APPEAL SUMMARY

Appeal ID: 24528	Project Address: 3580 SW River Pkwy
Hearing Date: 1/20/21	Appellant Name: Renee Snyder
Case No.: B-006	Appellant Phone: 5415217661
Appeal Type: Building	Plans Examiner/Inspector: John Cooley
Project Type: commercial	Stories: 2 Occupancy: B Construction Type: I-A
Building/Business Name: The Meriwether (Tenant: Dr. Todd Beck)	Fire Sprinklers: Yes -
Appeal Involves: Addition to an existing structure	LUR or Permit Application No.: 20-216499-CO
Plan Submitted Option: pdf [File 1]	Proposed use: B: Dental Clinic

CONSTRUCTION DRAWINGS FOR:
DR. TODD BECK

3580 SW RIVER PARKWAY, PORTLAND, OR 97239

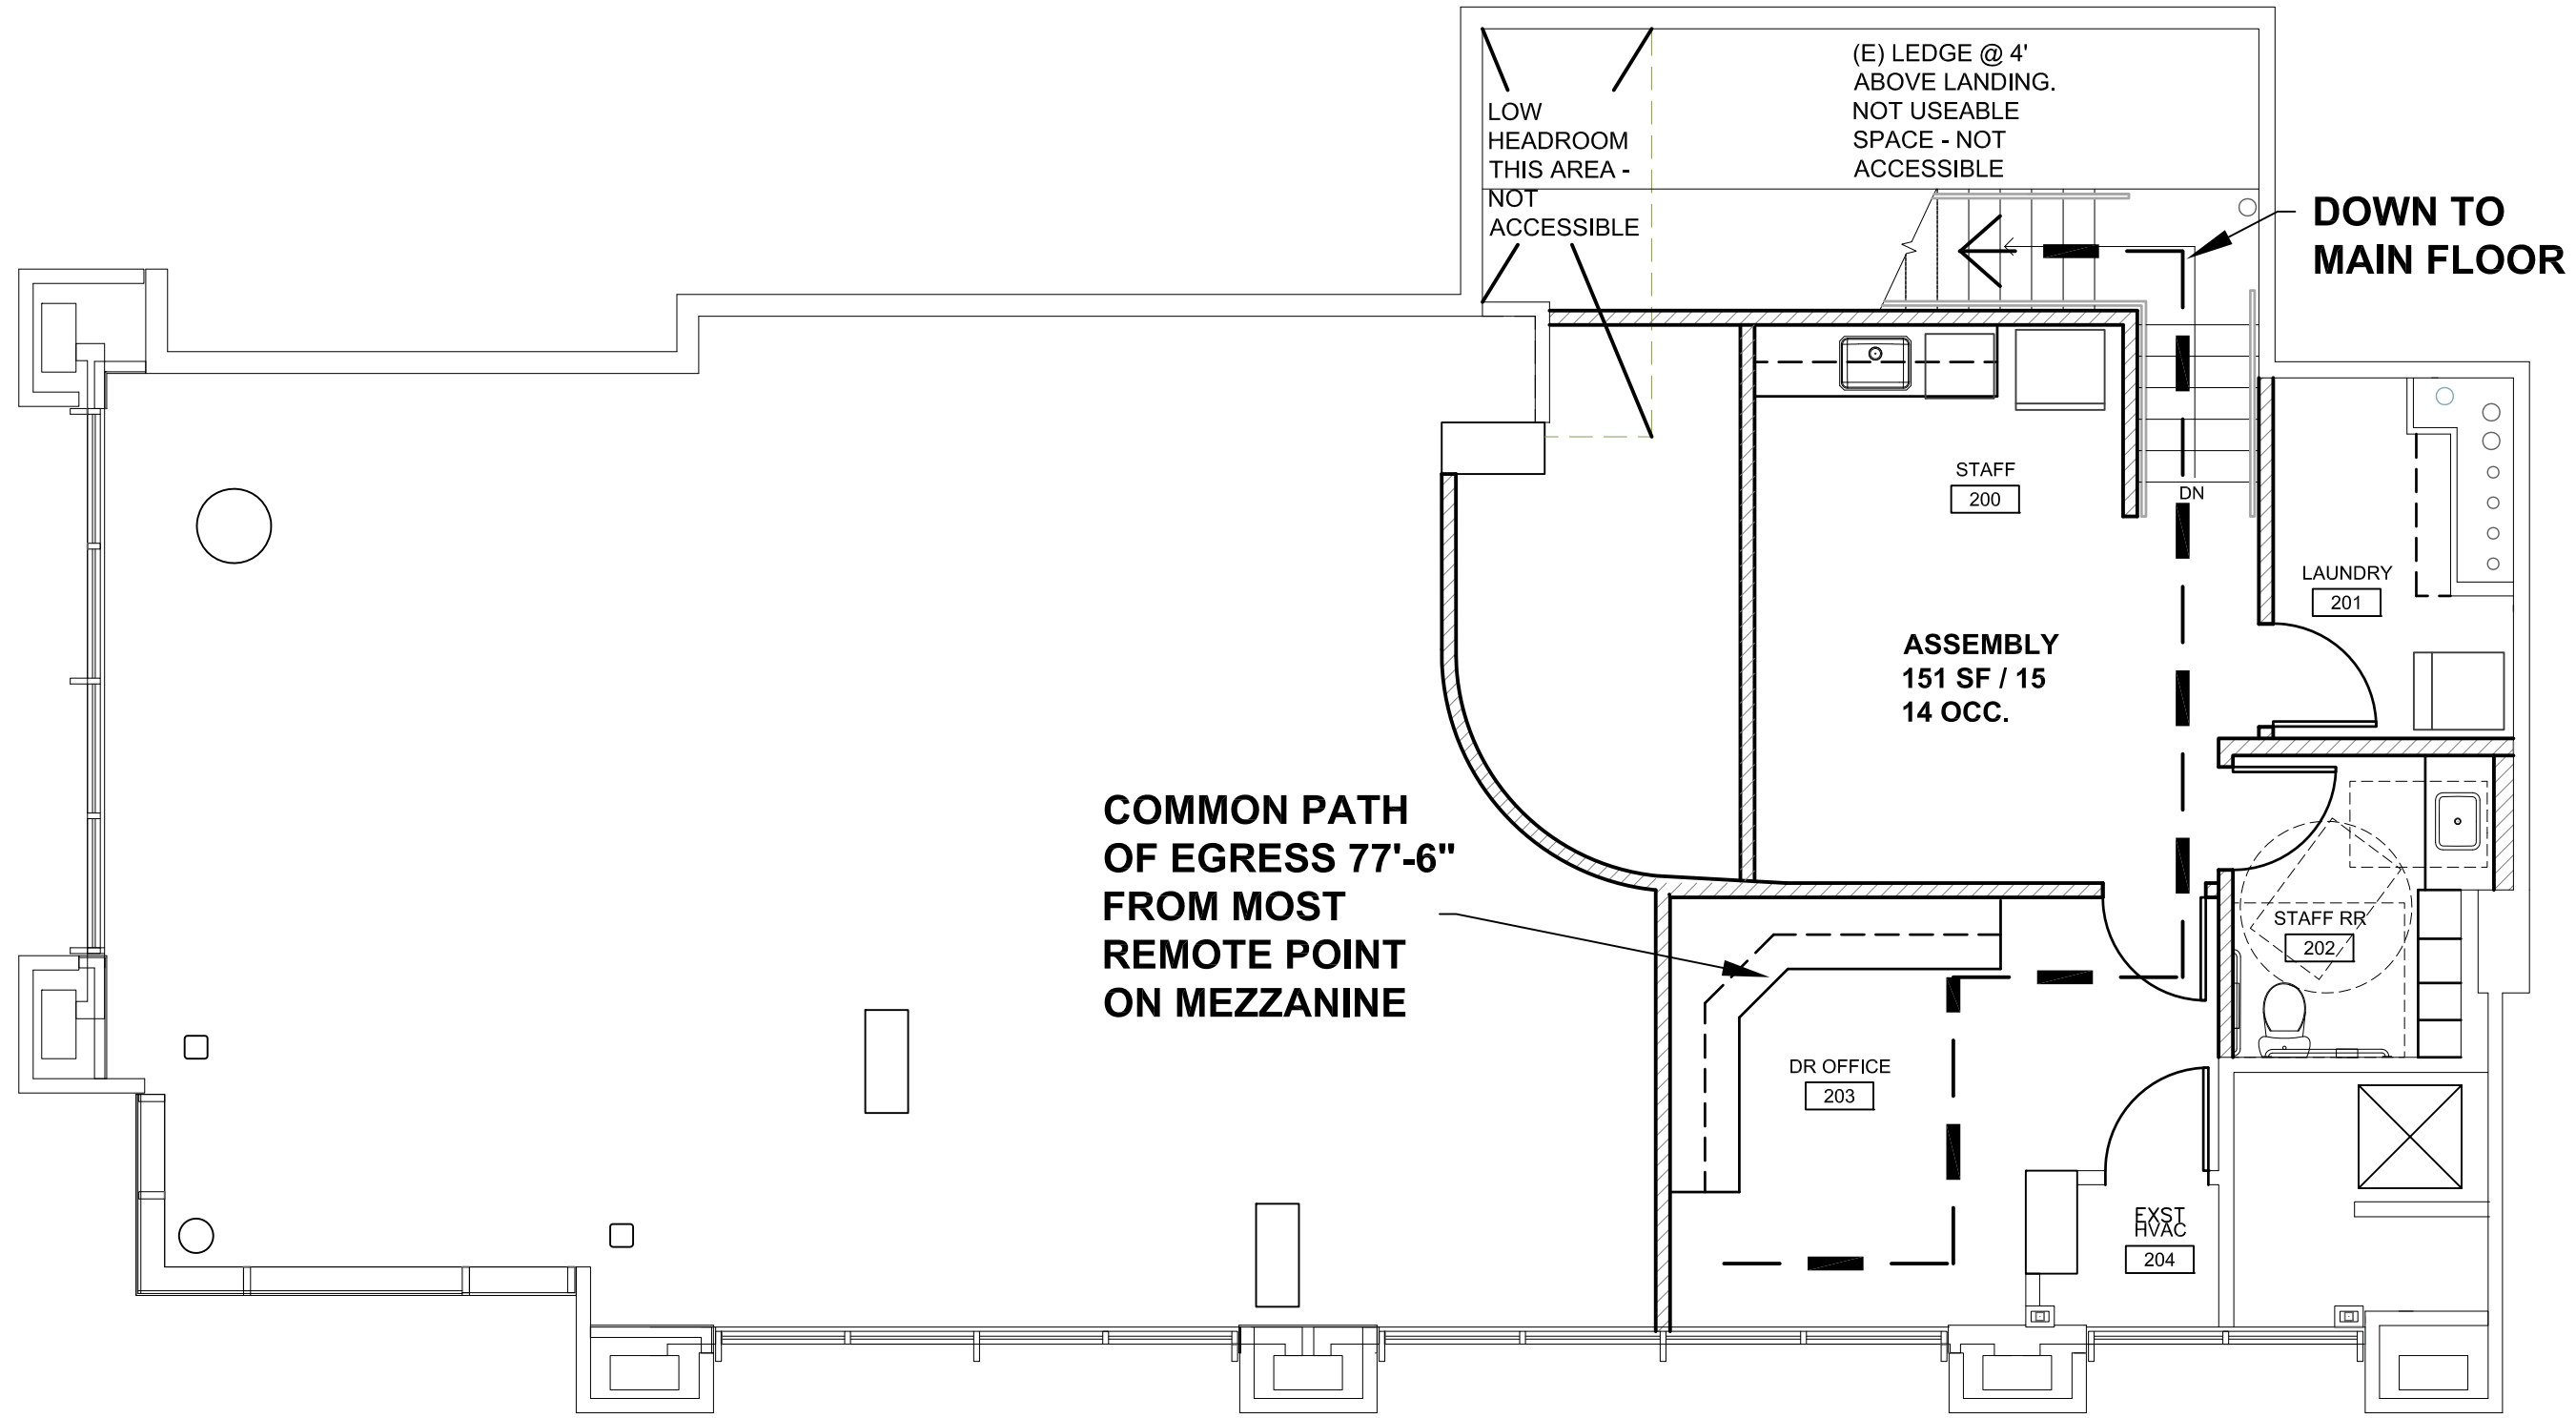
Code Section	Table 601
Requires	Per Table 601 For Type I-A Building 3-hour rated Primary Structural Frame (columns, girders, trusses) 2-hour rated floor construction and secondary members
Code Modification or Alternate Requested	Appeal to maintain approved appeal ID3338 for previous tenant. Proposed design would reduce mezzanine girder protection to 2-hours.
Proposed Design	<p>3-hour rated columns (per Table 601)</p> <p>2-hour rated floor girders, protected as part of 2-hour floor system</p> <p>2-hour rated floor construction (per table 601)</p> <p>Note: proposed change would only affect new tenant's second floor: does not affect existing building or primary structure</p> <p>Summary: Girder protection would be achieved as part of 2-hour floor system and secondary members, as allowed in table 601. See attached floor plans & details. The proposed tenant improvement includes change of occupancy from A-2 to B and a mezzanine conversion to second floor in an existing Type I-FR concrete building. The second floor footprint will also expand. The tenant space is separated from adjacent spaces by 1-hour and 3-hour walls (varies).</p>

Reason for alternative	<p>The argument for the previously approved appeal does not change due to the change of occupancy or mezzanine to 2nd floor conversion.</p> <p>The intent of the 3-hour requirement for structural frame is to delay collapse of a large building due to fire exposure, by protecting vertical load-carrying members for a theoretical time period (3 hours). The proposed reduction to 2-hours for specific members would not affect the overall</p>

building's integrity, as the second floor will be completely independent from the primary structure. The affected members will support only the second floor; i.e. failure of the second floor's structural members would have no life safety impact for the balance of the building.

The requirement for floor construction is 2-hour rated. All beams/girders will be protected within this 2-hour assembly which shall provide a more than adequate delay of collapse for the life-safety needs of the tenant space/proposed use.

Under this proposal, remaining portions of the structural frame (columns) are to remain protected w/3-hour rating. The proposed tenant space will also be fire-sprinklered throughout.

Reduction in minimum required protection of primary structural members in 1A construction from 3 hours to 2 hours as previously granted in Appeal #3338: Granted as proposed.
